**RE: Caminito Verde Subdivision
2827 Rio Grande Blvd NW
Grading & Drainage Plan
Engineer's Stamp Date: 02/11/2026
Hydrology File: G12D002
Case # HYDR-2026-00053**

Based upon the information provided in your submittal received 02/19/2026, the Grading & Drainage Plan is approved for Grading Permit and Building Permit. Please attach a copy of this approved plan in the construction sets for Building Permit processing along with a copy of this letter.

Caminito Verde Subdivision

GRADING & DRAINAGE PLAN

CG-101

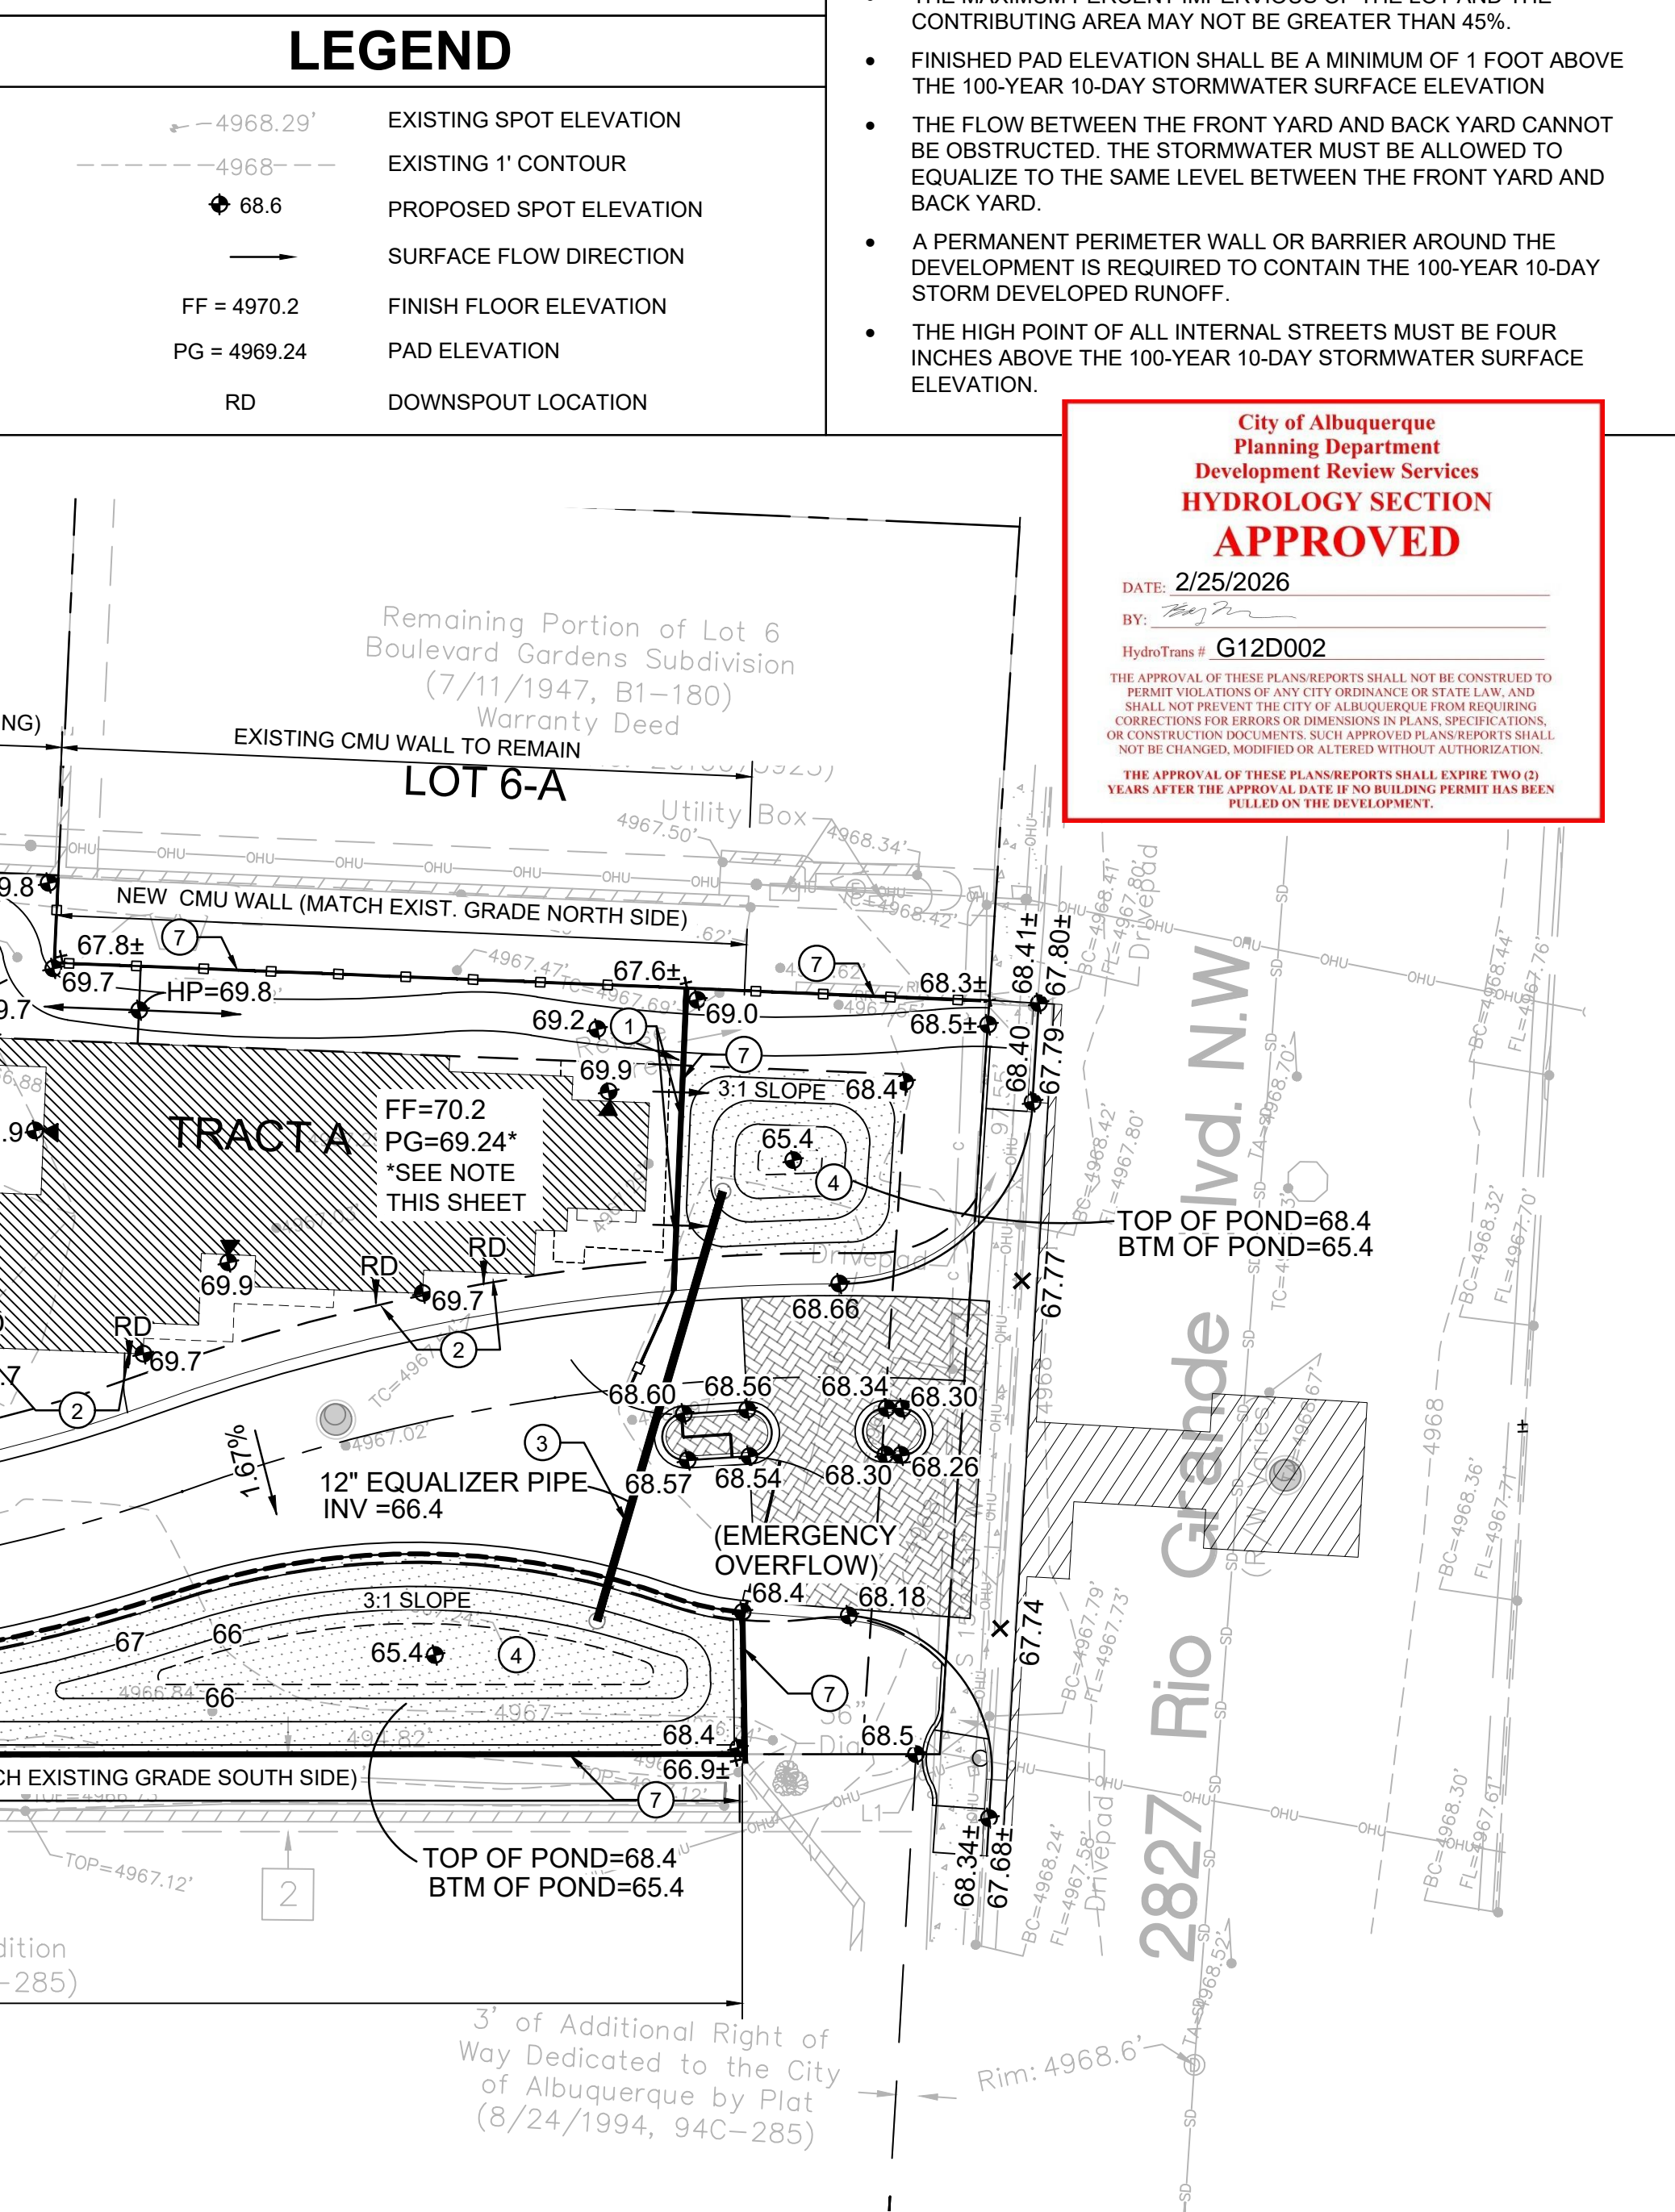
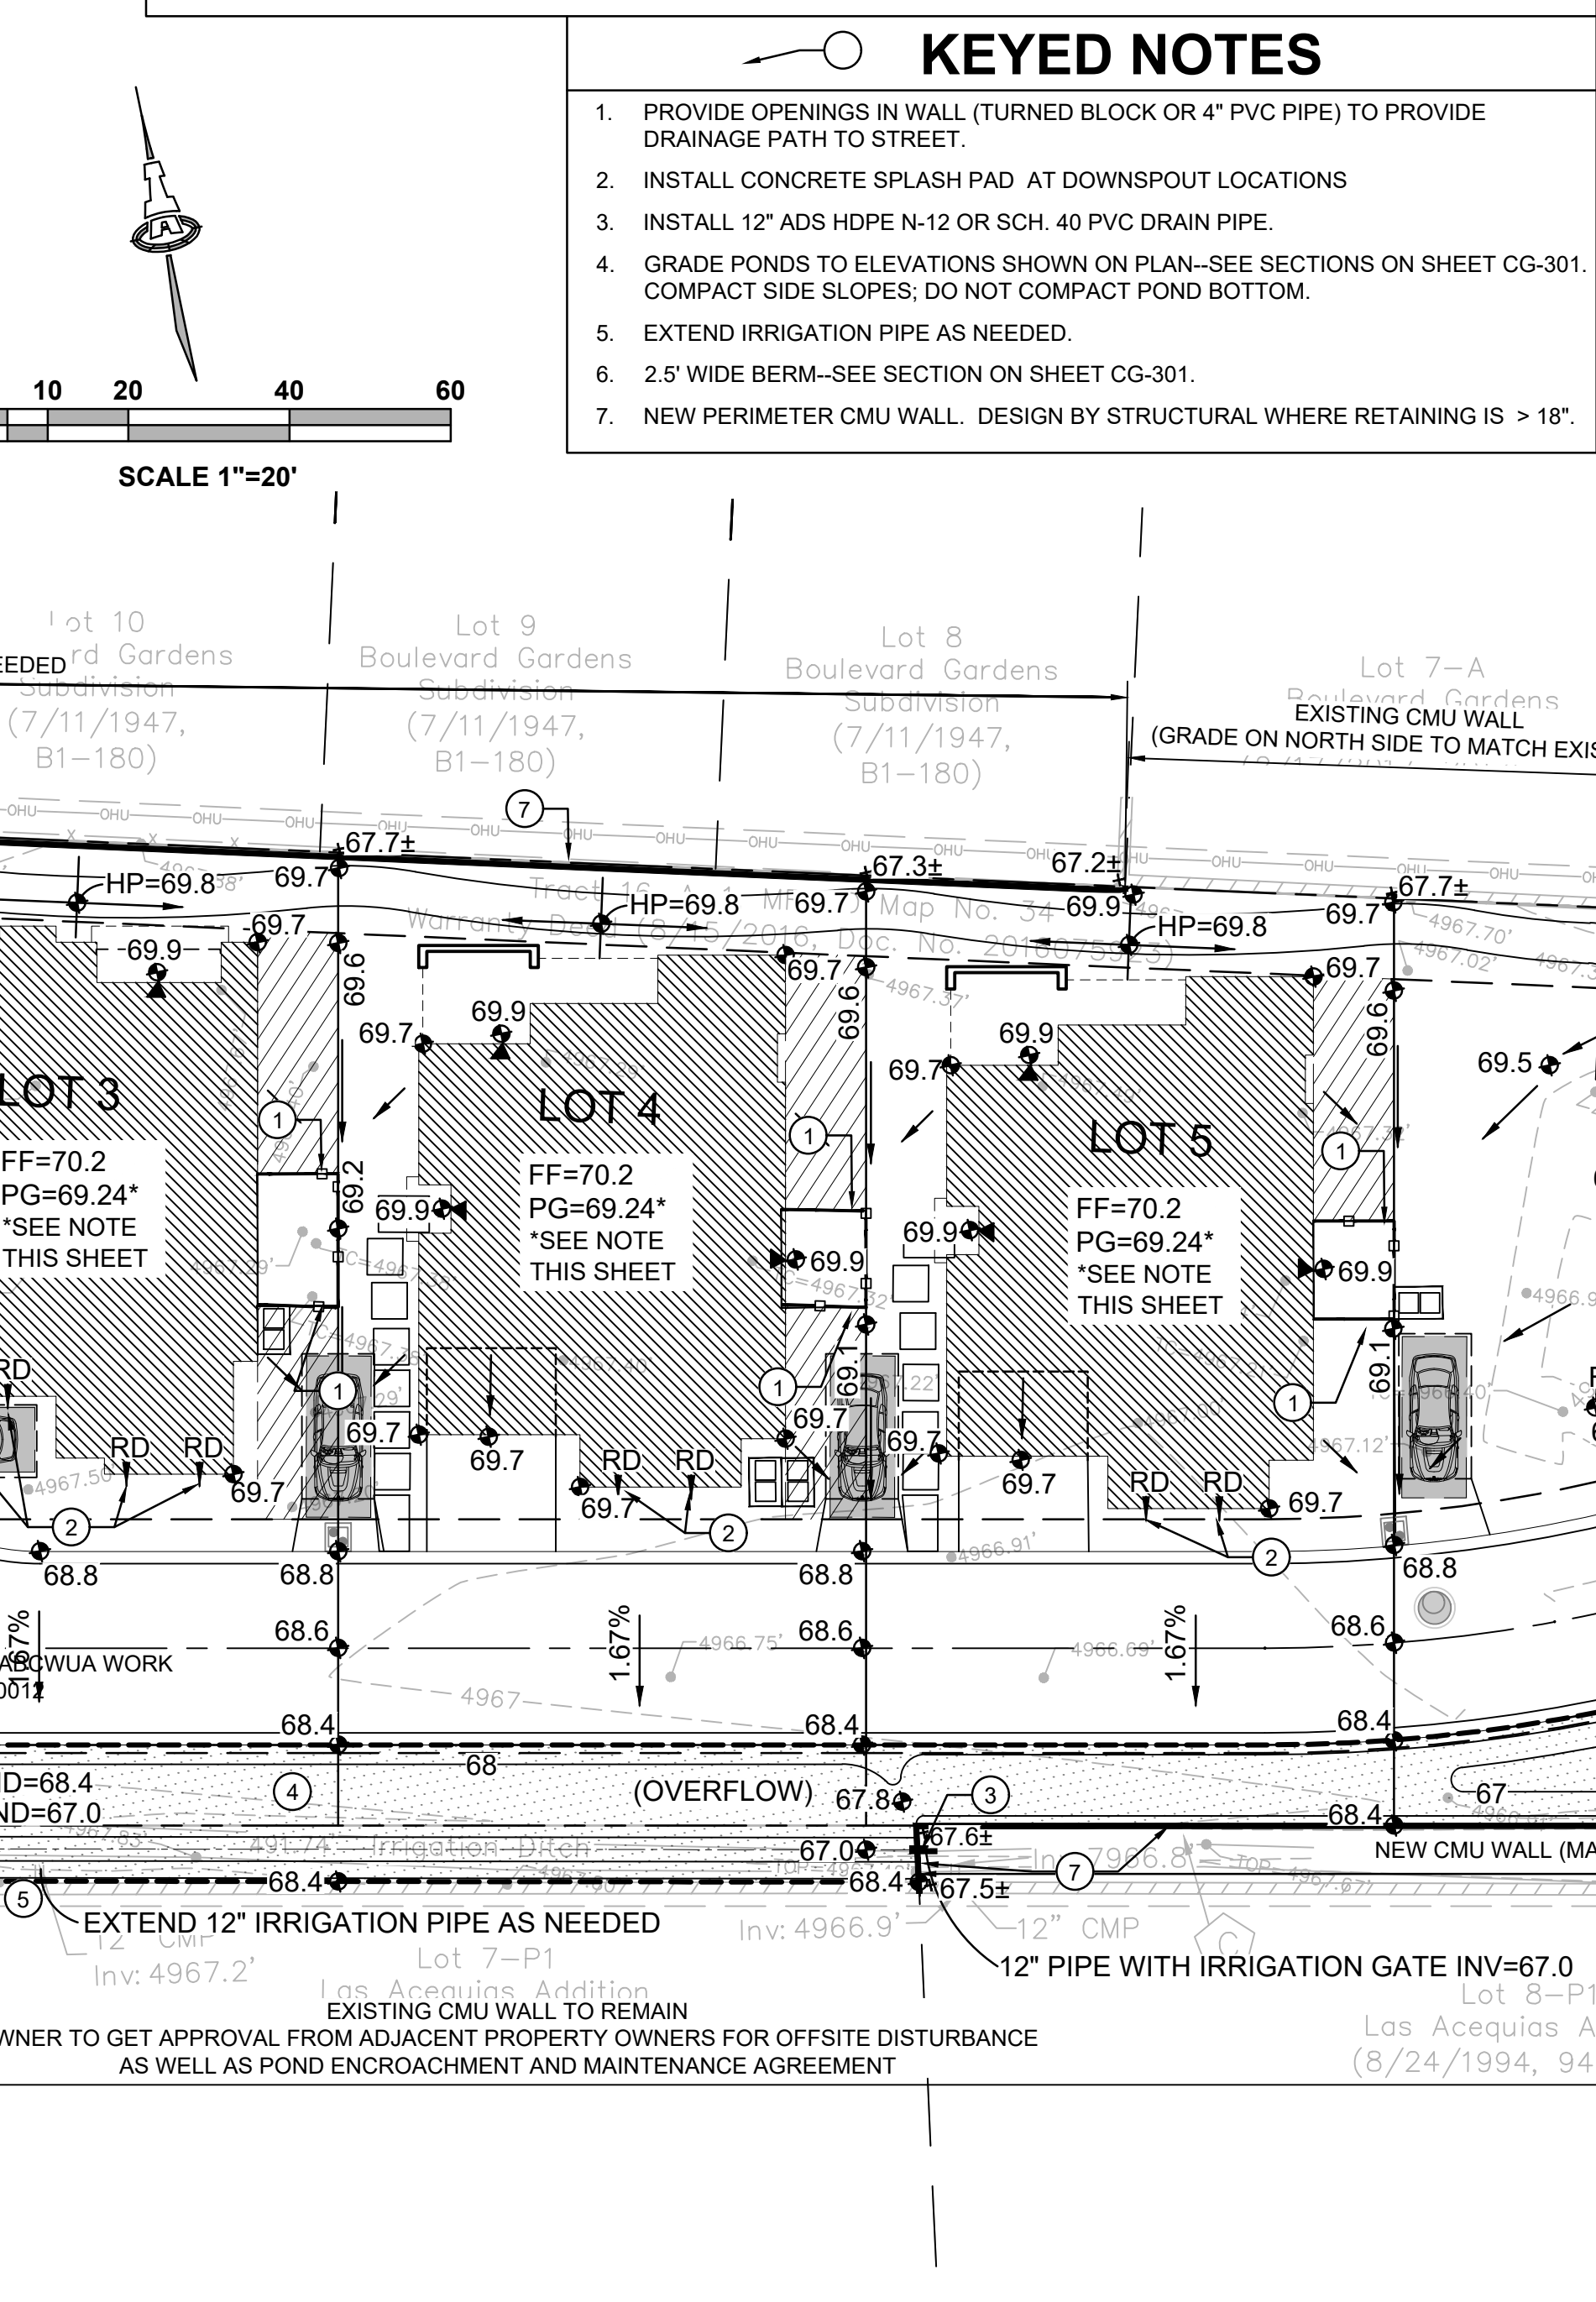
1. Engineer's Certification, per the DPM Part 6-14 (F): Engineer's Certification Checklist For Non-Subdivision is required.
2. Please provide the Drainage Covenant with Exhibit A for the stormwater quality ponds per Article 6-15(C) of the DPM prior to Permanent Release of Occupancy. Please submit the original copies along with the \$ 25.00 recording fee check made payable to Bernalillo County to the Hydrology Section of Development Review Services on the Ground floor of Plaza de Sol.
